Wauwatosa, WI

Board of Public Works

Meeting Agenda

Wednesday, September 24, 2025

7 LANDSCAPE AREAS
1" = 30'-0"

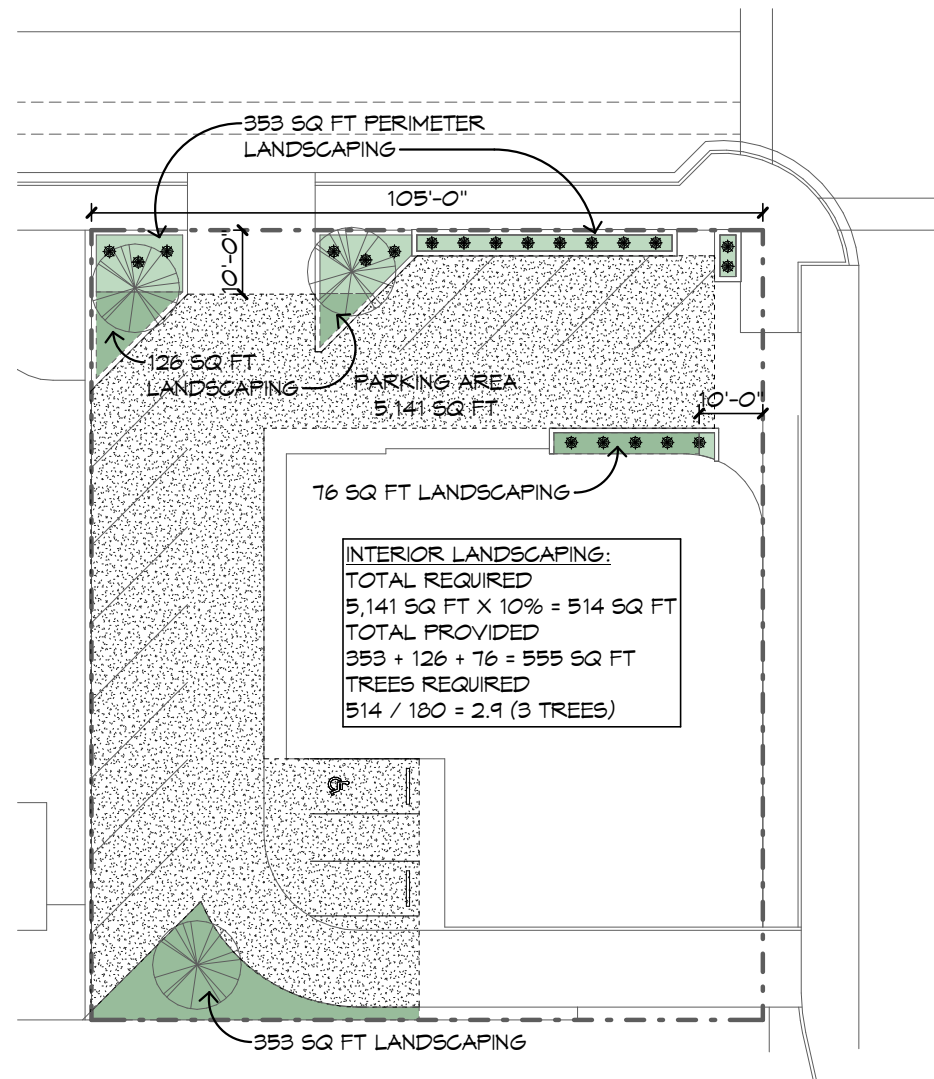
Why do the proposed planters in the perimeter must be provided above grade?

Our calculations show that the interior landscaping area that is being provided is 353 SF + 126 SF = 479 SF, or 9.3%.

Response: The proposed 18” high planters along North Avenue were designed to be above grade to serve as both a barrier between the sidewalk and parking stalls, and to add additional good soil for the plantings above the contaminated soil identified in the DNR report. No requirements for a raised bed were identified in the Guide to Landscaping and Screening Code. If the planters are being classified as a fence under 15.28.030(B.1), we are willing to reduce the width of the planter by 18” to be compliant. If a raised planter is not desired by the board, we ask that we be given a variance on the guarantee for plantings located above the contaminated soil.

Response: We would like to understand why the 76 sq ft of interior landscaping along the building does not count towards the calculation, and where else within the site would be counted. If a different location is identified that does not reduce the parking count, we will remove the landscaping in front of the building and add it in the desired location.

NEW SITE PLAN
1" = 20'-0"

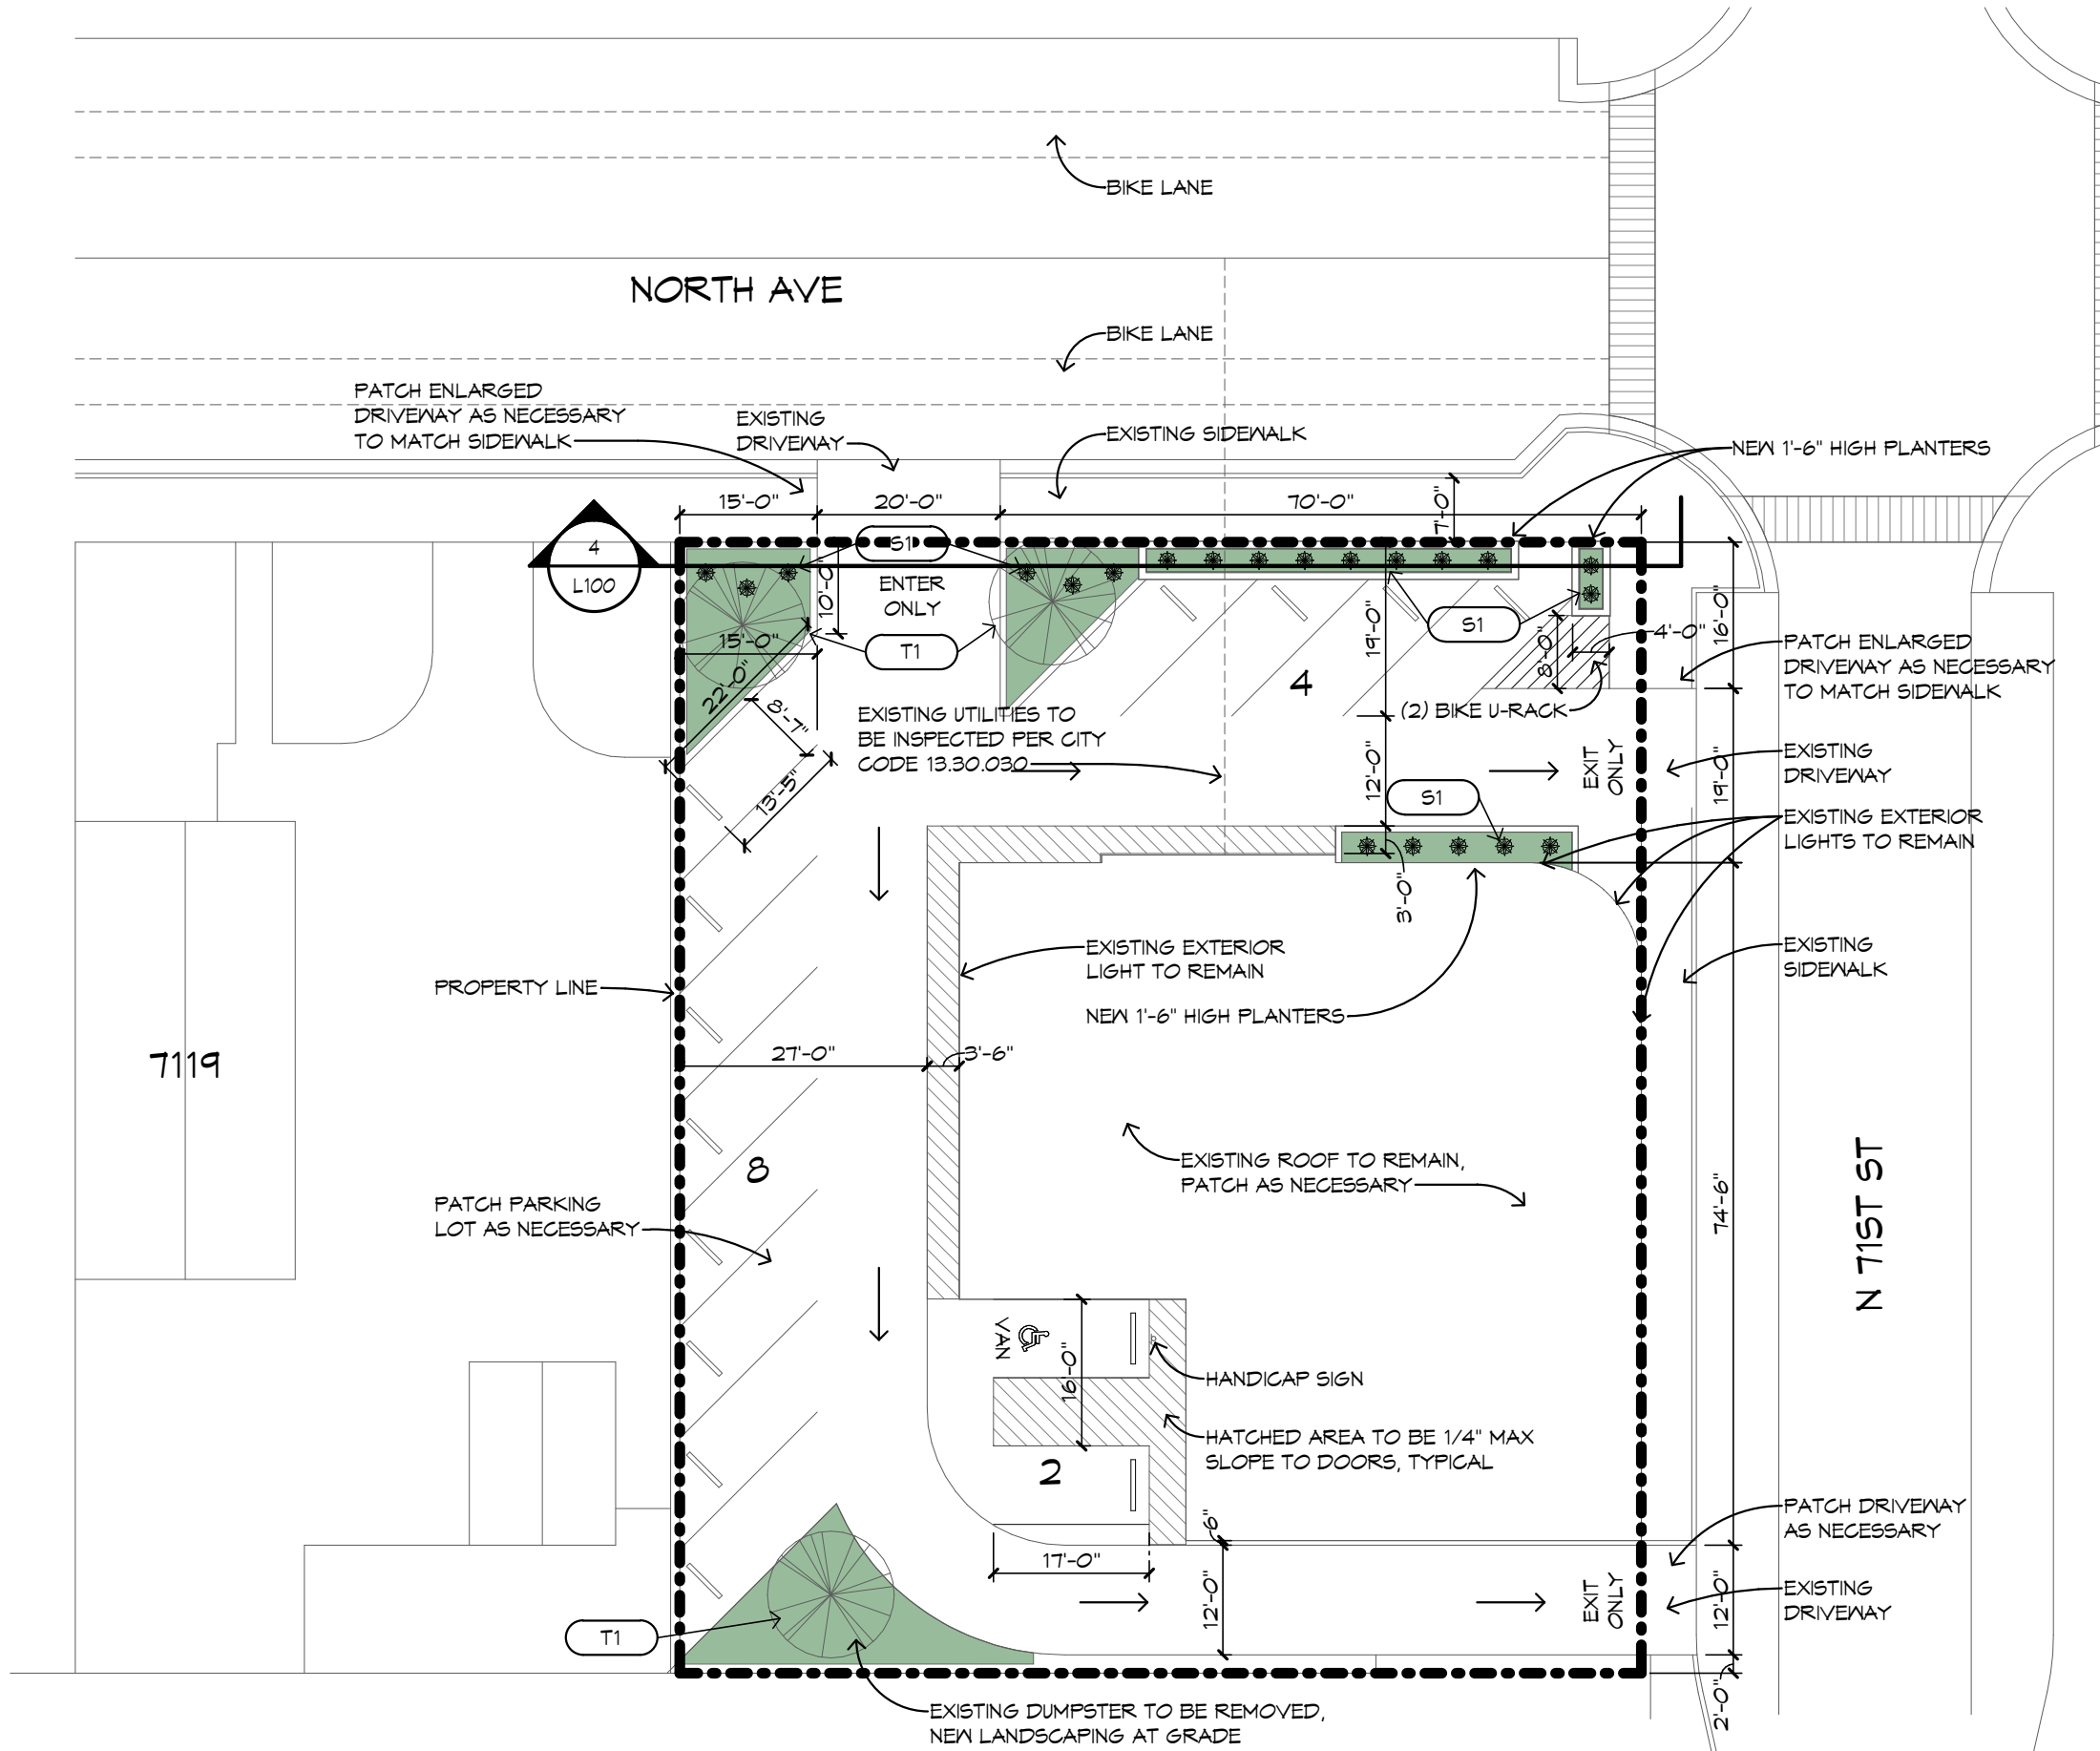
The plans show that 9 parking spaces are required, but because this property is within the North Ave overlay district, there is no parking requirement.

The previously approved site plan from 1981 showed that there were 13 parking spaces. The proposed plan shows 14 parking spaces.

I am concerned about how someone parking in the van accessible spot will be able to back out based on its close proximity to the building. Does a turning template show that a vehicle can safely back out of this spot if there are vehicles parked in the adjacent spot or across the drive aisle?

Could this area be reconfigured such that it is for van spot and access aisle only? The spots could then be moved south from the building and then angled to match what is being proposed on the other side of the access aisle. A small landscaping island could then be added in between the van spot and the building to get the overall site to meet the 10% requirement.

Response: If the North Ave Overlay District overrides the standard parking requirement, we will omit that line item from the drawings.

Response: The proposed project is for the auto shop to be replaced with a Flash Laundromat. The number of parking stalls within walking distance for a customer carrying laundry is directly tied to the financial viability of this use. If we are unable to gain any additional stalls from the (13) identified in the 1981 approved site plan, we will need to withdraw this application and either leave the site as-is or restore it to the 1981 condition, to be determined by the City of Wauwatosa.

Response: A turning template using an 11'-6" interior and 19'-2" exterior radius was used during the drafting of the site plan and does clear the building and angled parking. In order to meet the clearances for a 14'-6" interior and 25'-6" exterior radius turning template, the van accessible stall would need to switch places with the second stall, and the second stall would be identified as a compact stall. If this change is desired, we will update the plan accordingly.

Response: If this area is reconfigured to be a van spot only, we would be reduced to (13) parking stalls and the site plan revisions would become infeasible.

CITY OF WAUWATOSA ENGINEERING SERVICES SECTION	
2025 SIDEWALK REPAIR PROGRAM	
11 PEDESTRIAN RAMPS @ 2506 WAUWATOSA AVE NE CORNER OF WAUWATOSA AVE & WRIGHT ST	
REFERENCES:	WAUWATOSA CONTRACT NO.: 25-19
SCALE: AS SHOWN	DRAWN BY: RC CHECKED BY: JS
SHEET 1 OF 4	FILE NAME: 76TH & WRIGHT_PROP.dwg

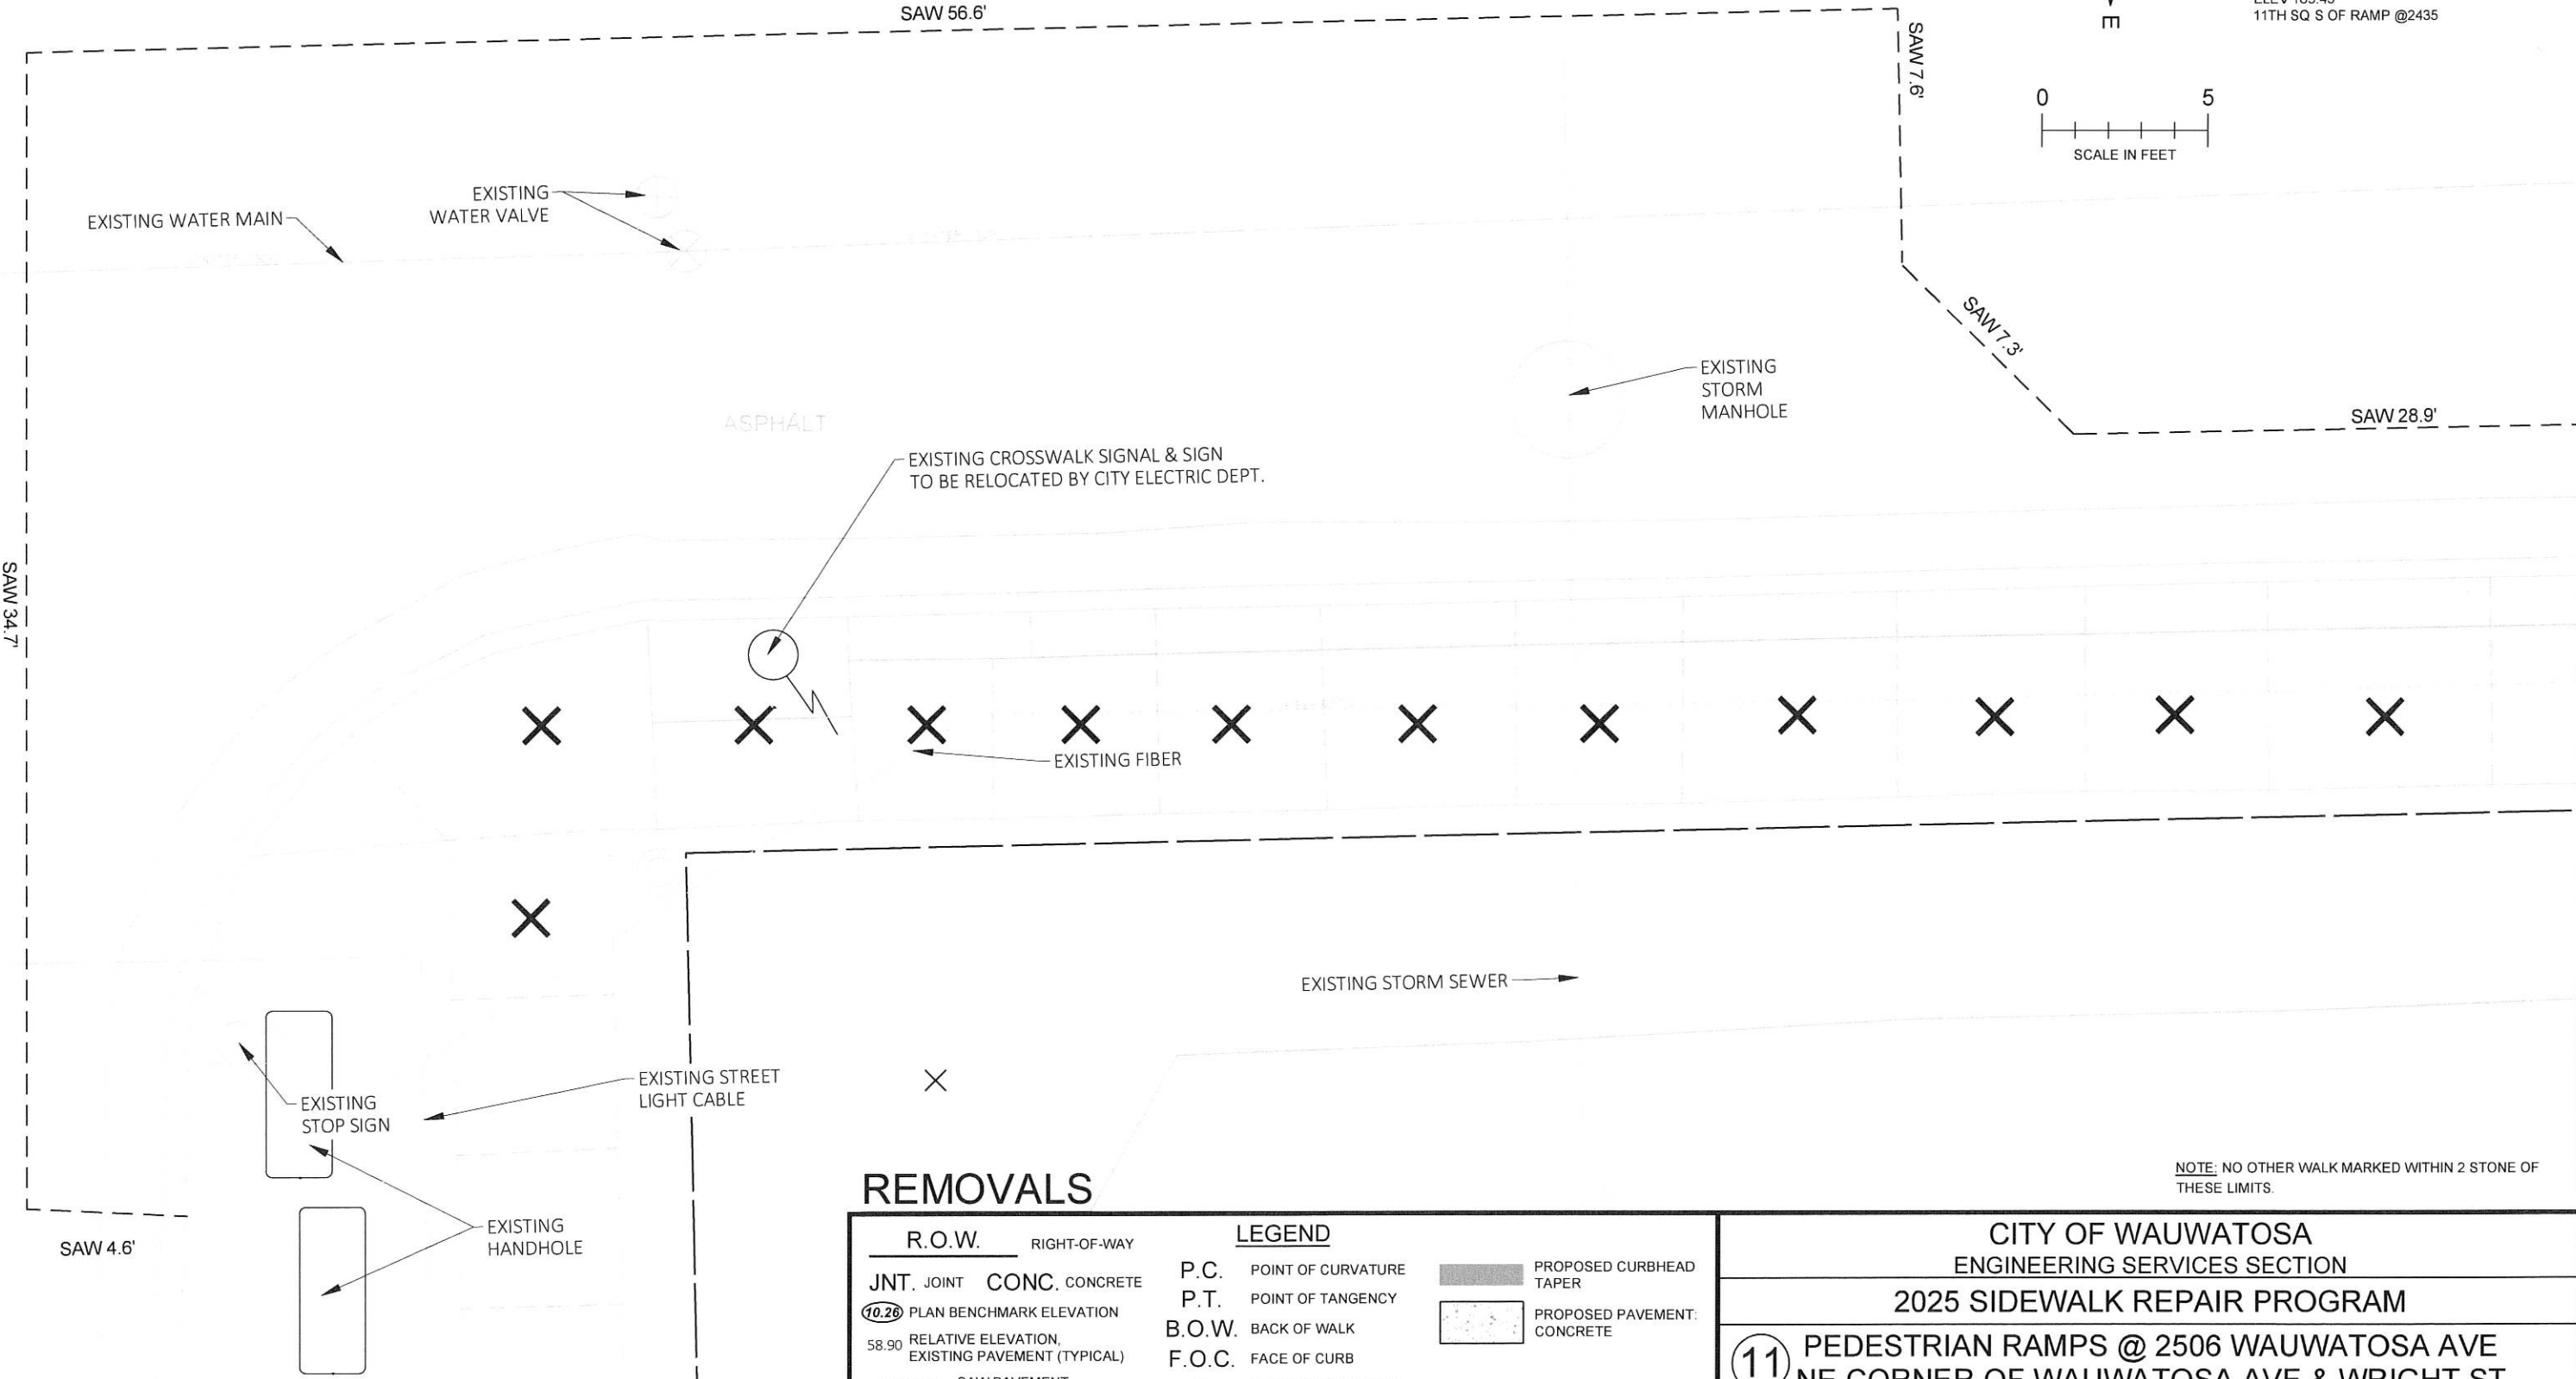
CONTRACT MODIFICATION DESCRIPTION: Adding sidewalk ramp replacement
at Wauwatosa Ave. and W. Wright St.

Add Wauwatosa Ave. & Wright St. ramp sheets.
